ITEM: 6.3	COMMITTEE OF ADJUSTMENT REPORT SUMMARY MINOR VARIANCE APPLICATION FILE NUMBER A129/23 71 DORENGATE DRIVE, WOODBRIDGE
------------------	---

**COMMITTEE OF ADJUSTMENT REPORT
MINOR VARIANCE APPLICATION
A129/23
71 DORENGATE DRIVE, WOODBRIDGE**

ITEM NUMBER: 6.3	CITY WARD #: 2
APPLICANT:	Maria Bello
AGENT:	MHBC Planning Limited
PROPERTY:	71 Dorengate Drive, Woodbridge
ZONING DESIGNATION:	See below.
VAUGHAN OFFICIAL PLAN (2010) DESIGNATION:	Vaughan Official Plan 2010 ('VOP 2010'): "Low-Rise Residential"
RELATED DEVELOPMENT APPLICATIONS:	None
PURPOSE OF APPLICATION:	Relief from the Zoning By-law is being requested to permit a proposed gazebo/cabana, pool terrace and driveway widening.

EXISTING SITE PLAN WITH PROPOSED CABANA 1
1:100 A101

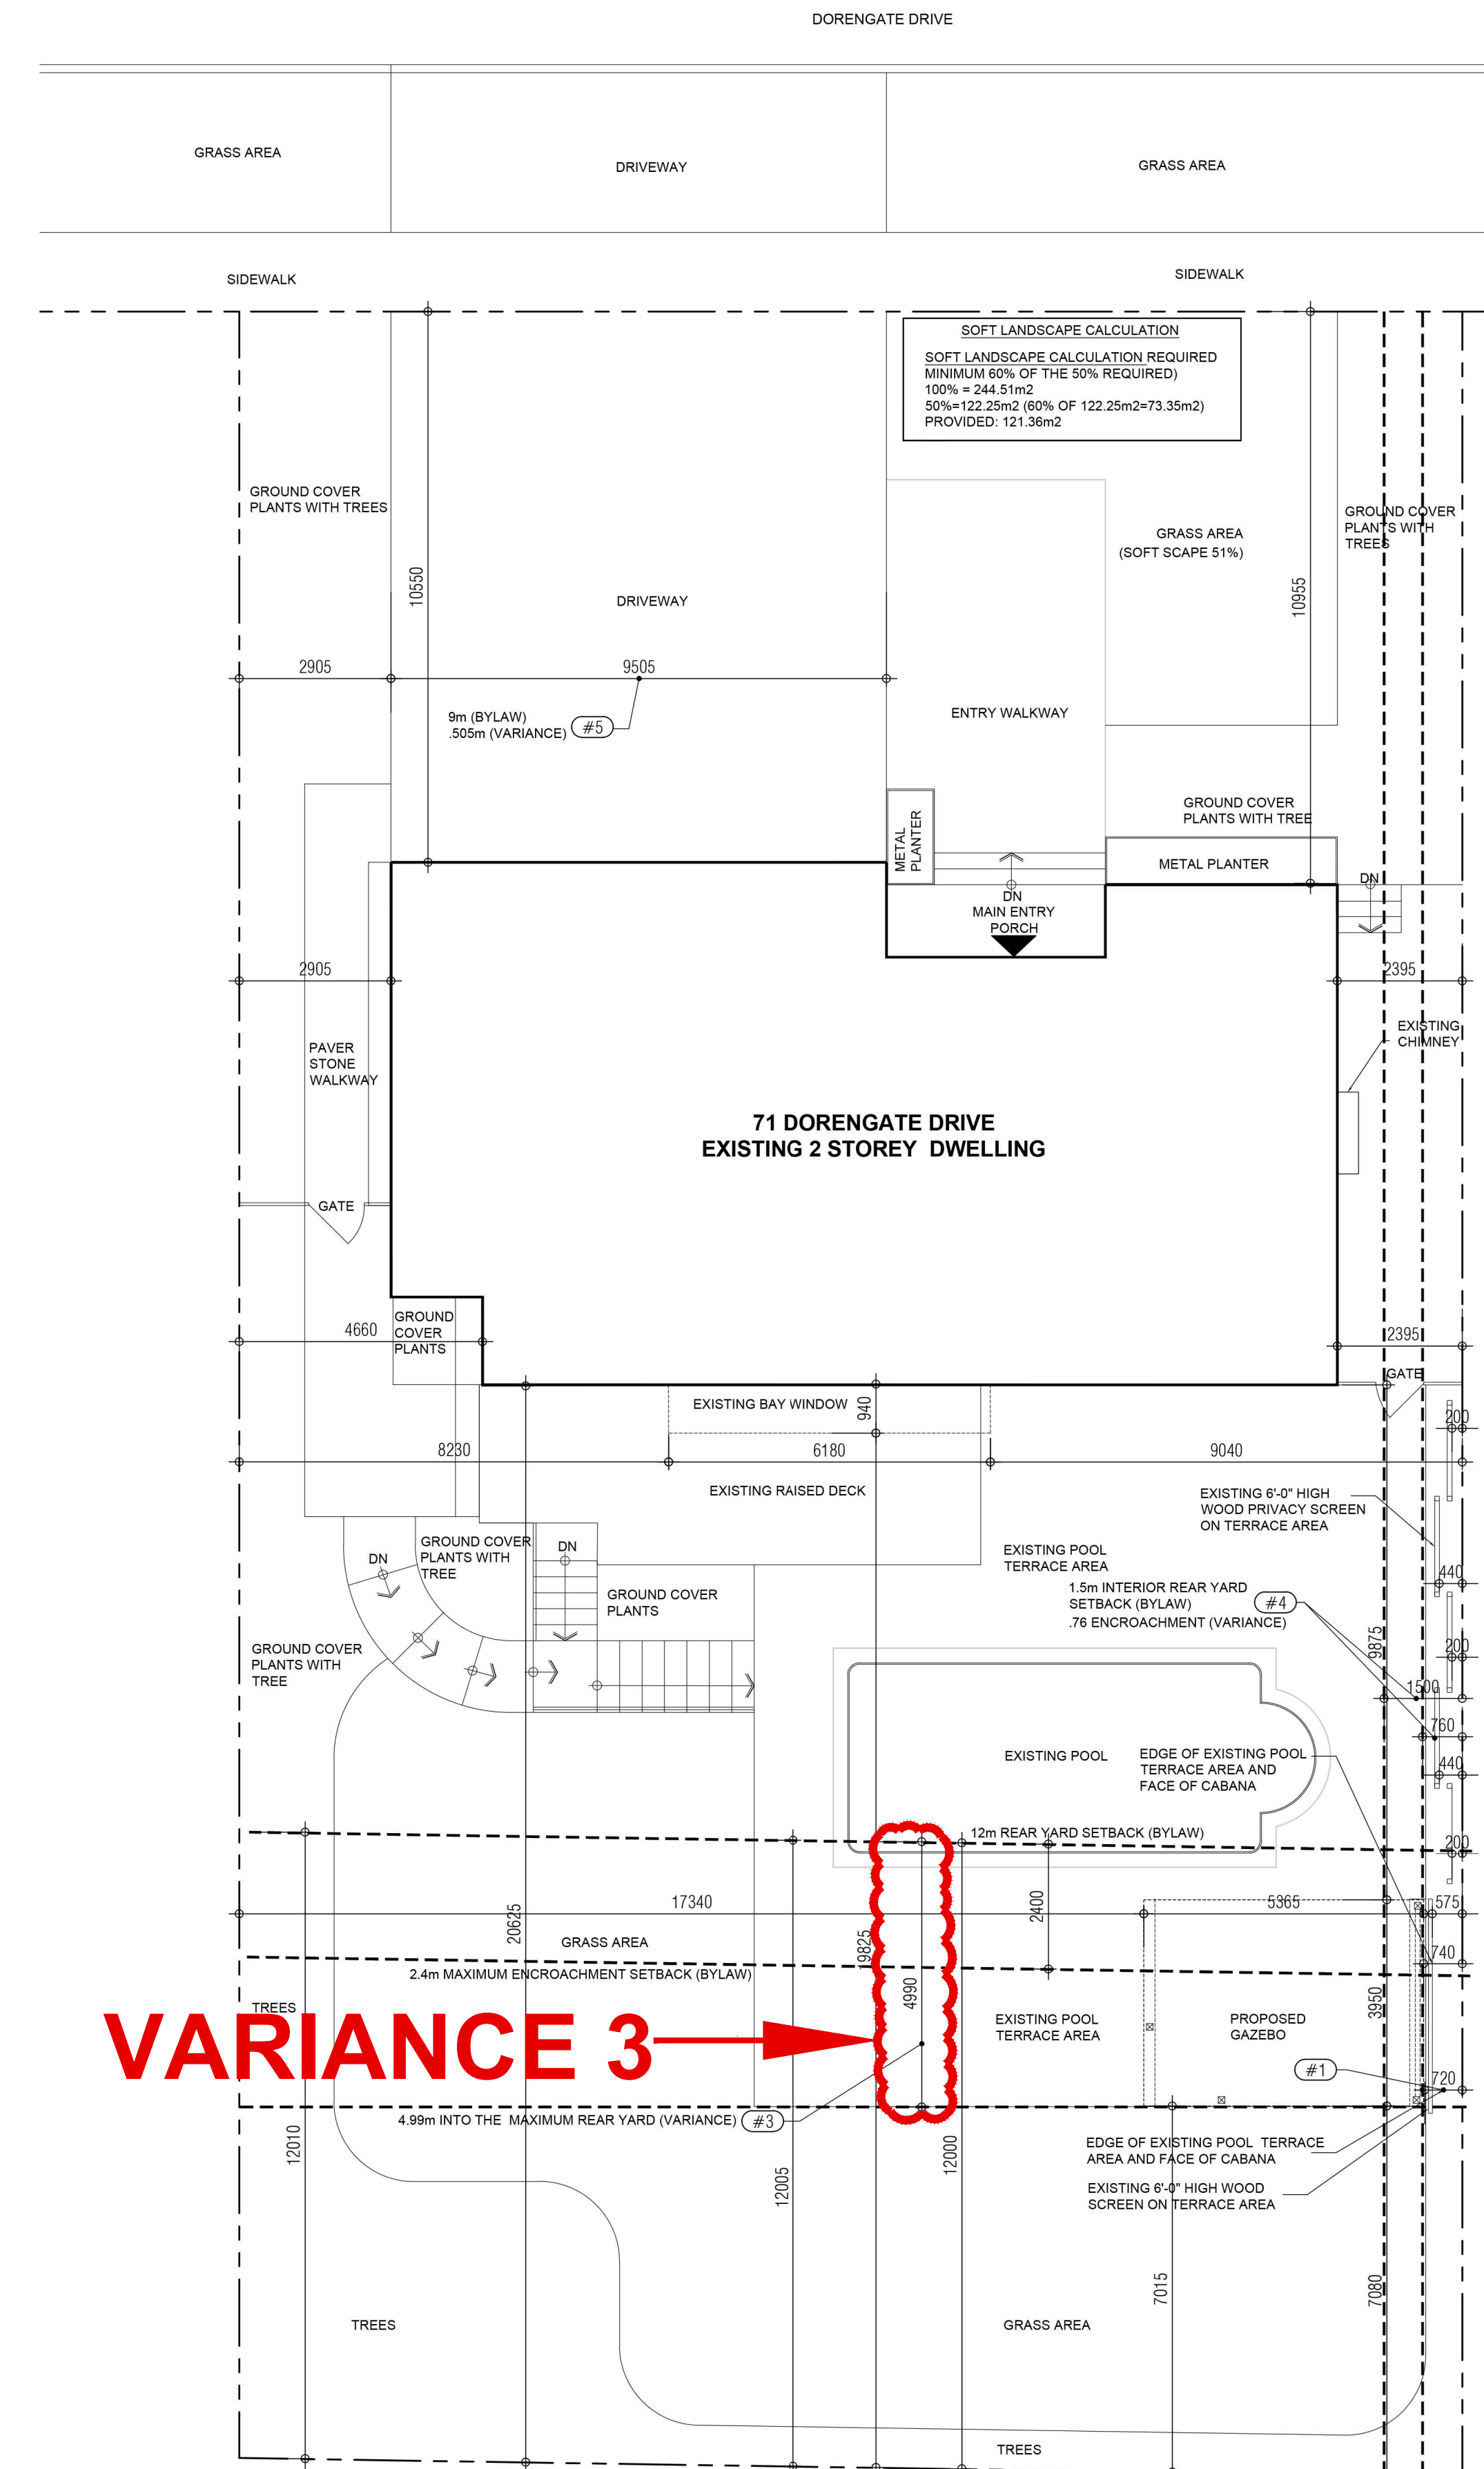
The Development Planning Department has no objection to setback Variances 1, 3, and 4. The proposed interior side lot line setback is sufficient to accommodate access and maintenance. The abutting property to the east, 75 Dorengate Drive, also has screening vegetation along the side lot line where the reduced setback is proposed. The proposed rear yard setback is sufficient to accommodate the existing screening vegetation on the property and for access and maintenance purposes. As such, the proposed cabana will not pose any adverse use or privacy impacts to the abutting properties.

The Development Planning Department also has no objection to Variance 2 for the cabana height. The rear yard has a slope which runs from northwest to southeast. The rear yard contains a pool with patio. The south and eastern sides of the patio have a retaining wall to provide for a level surface. The retaining wall is highest at the southeast corner due to the topography of the lot. The cabana is proposed in the southeast corner of the patio, and the grade at the base of the retaining wall is utilized when calculating the cabana's height. The height of the cabana, when measured from the patio is 3.05 metres, and 4.4 metres when factoring in the grade at the base of the highest portion of the retaining wall. The cabana will be heavily screened from the abutting residential property to the east, 75 Dorengate Drive, through a combination of an existing cedar hedge and existing mature trees. It will be screened to the south as the rear yard abuts a forested area of the neighbouring institutional property, St. Margaret Mary Roman Catholic Church. The residential property to the west, 65 Dorengate Drive, sits higher

VARIANCE 5

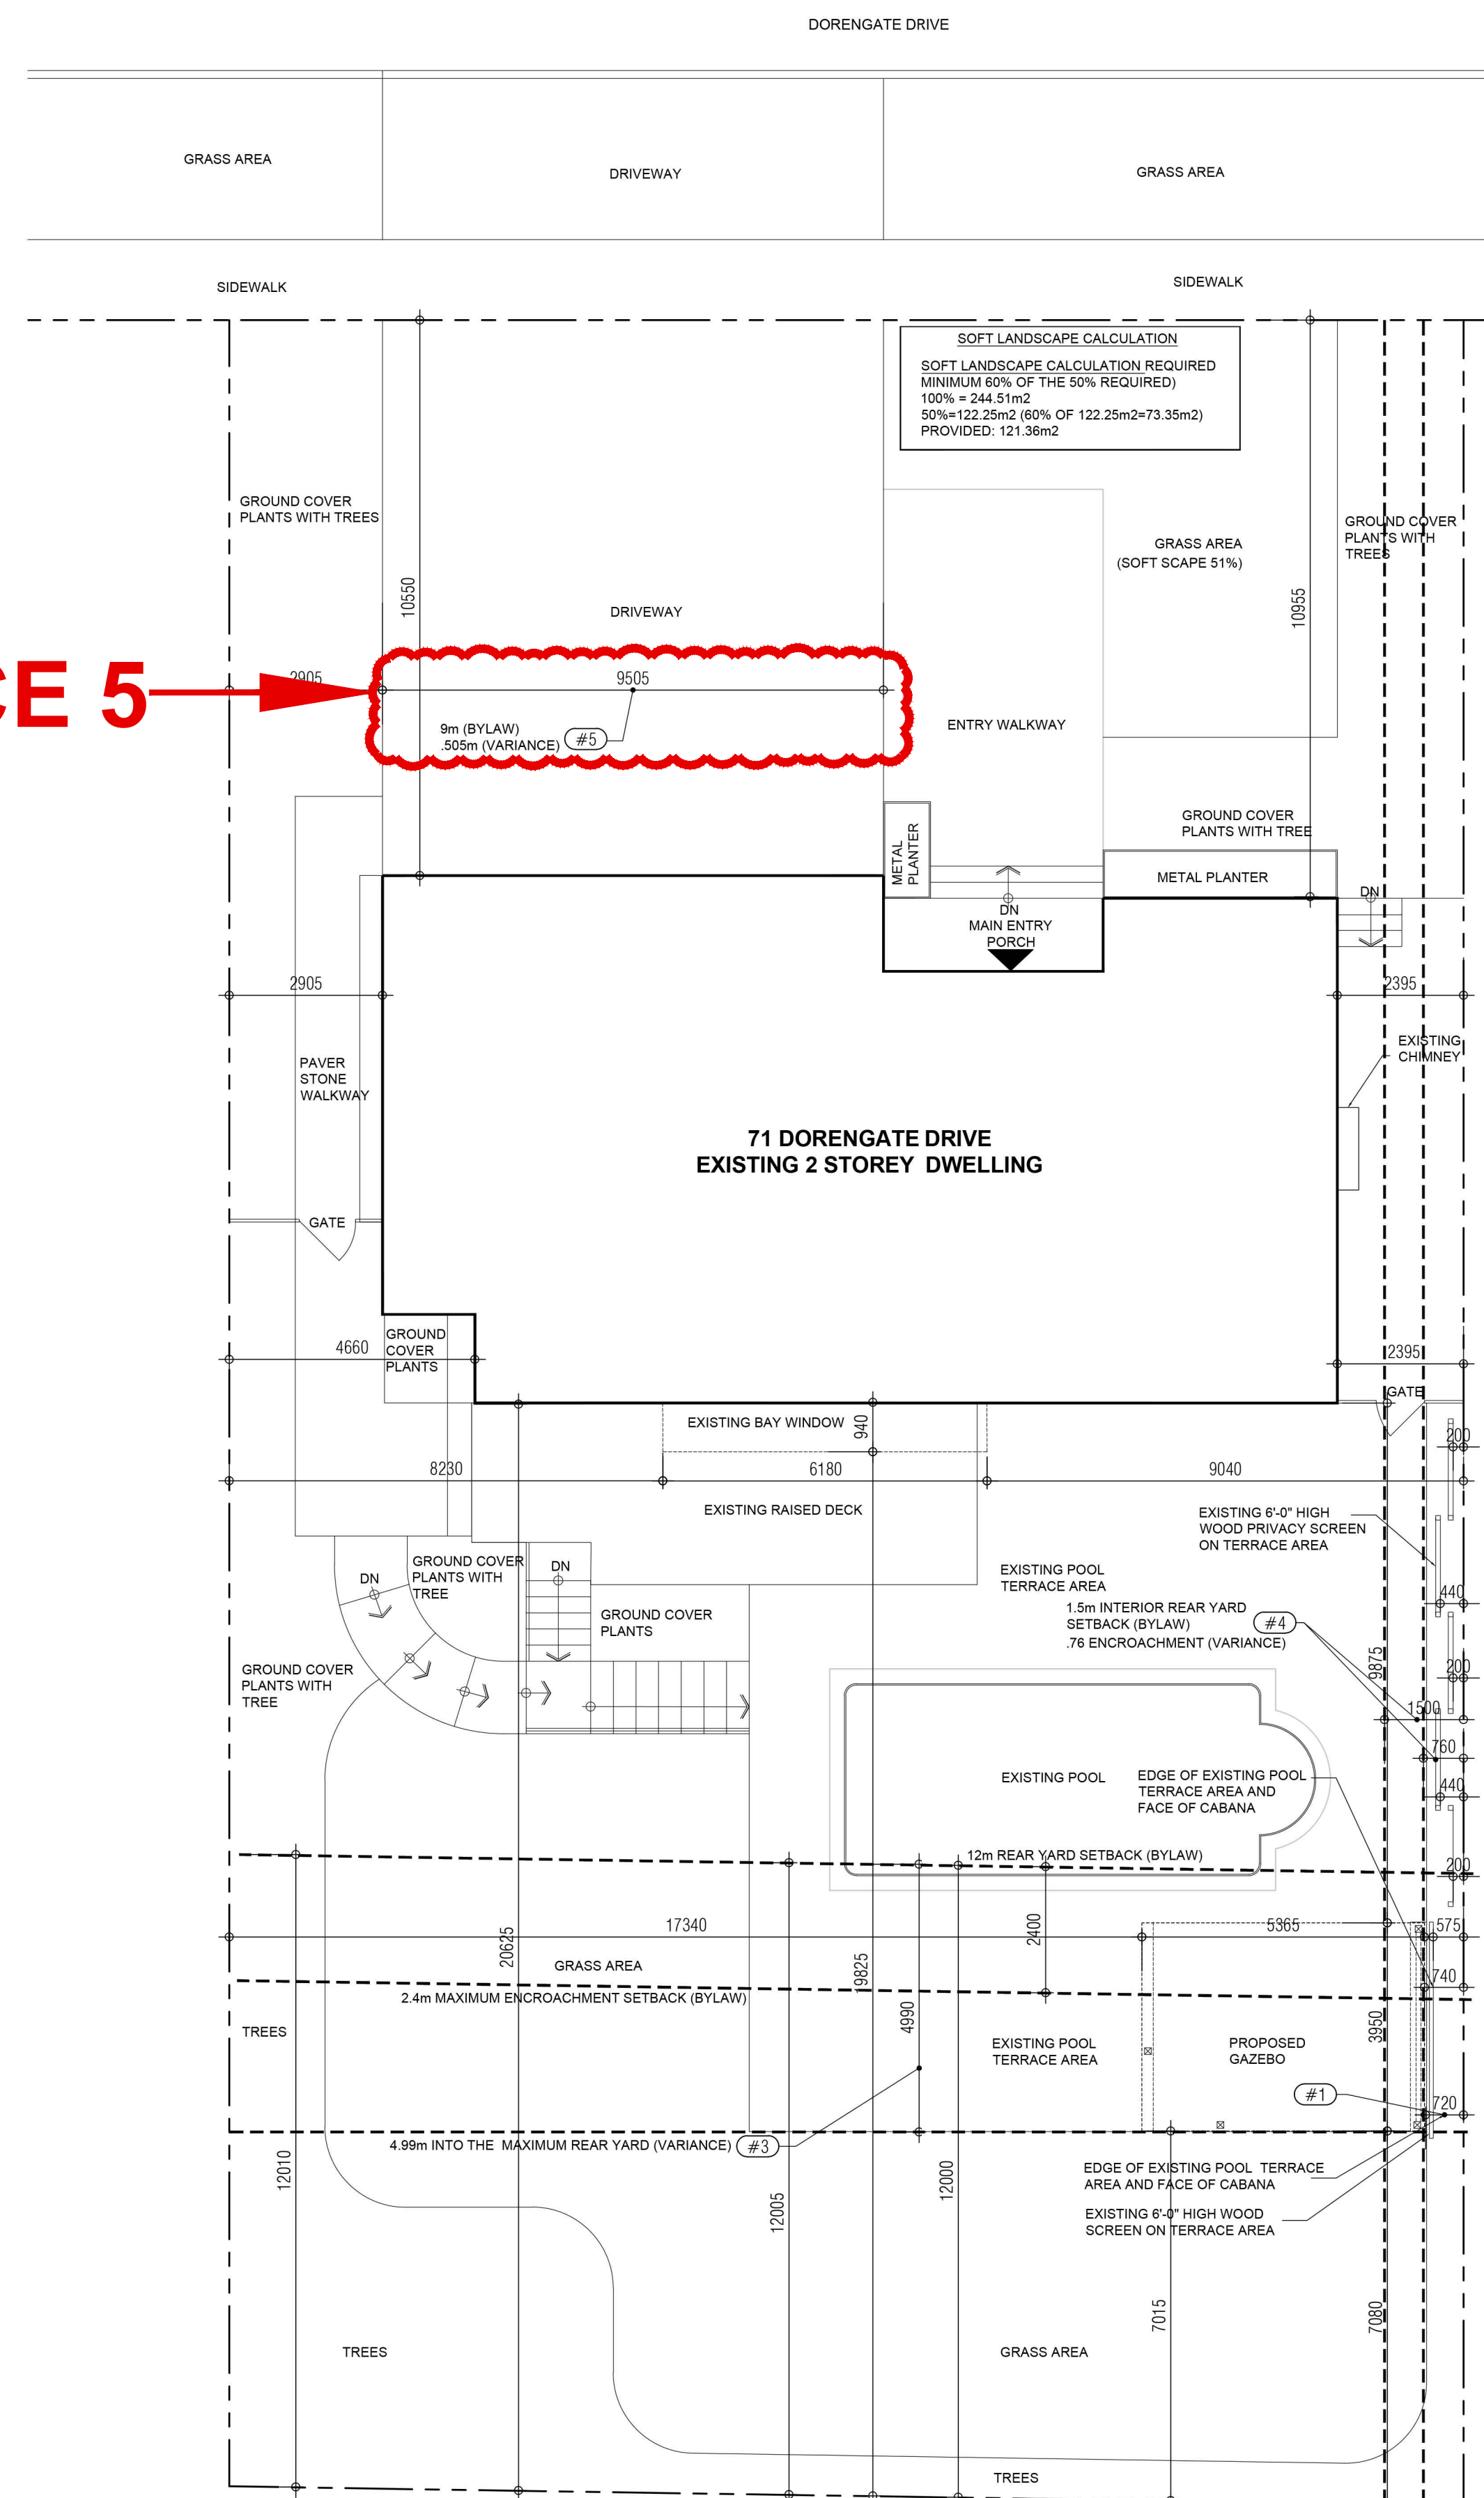
The Development Planning Department has no objection to Variance 5 to permit a maximum driveway width of 9.505 metres. The 0.51 metre increase in width is negligible from a visual perspective in part due to the relatively wide lot frontage (23.08 metres). As such, the proposed driveway is not anticipated to have adverse impacts to the existing streetscape as a sufficient degree of front yard soft landscaping is being maintained.
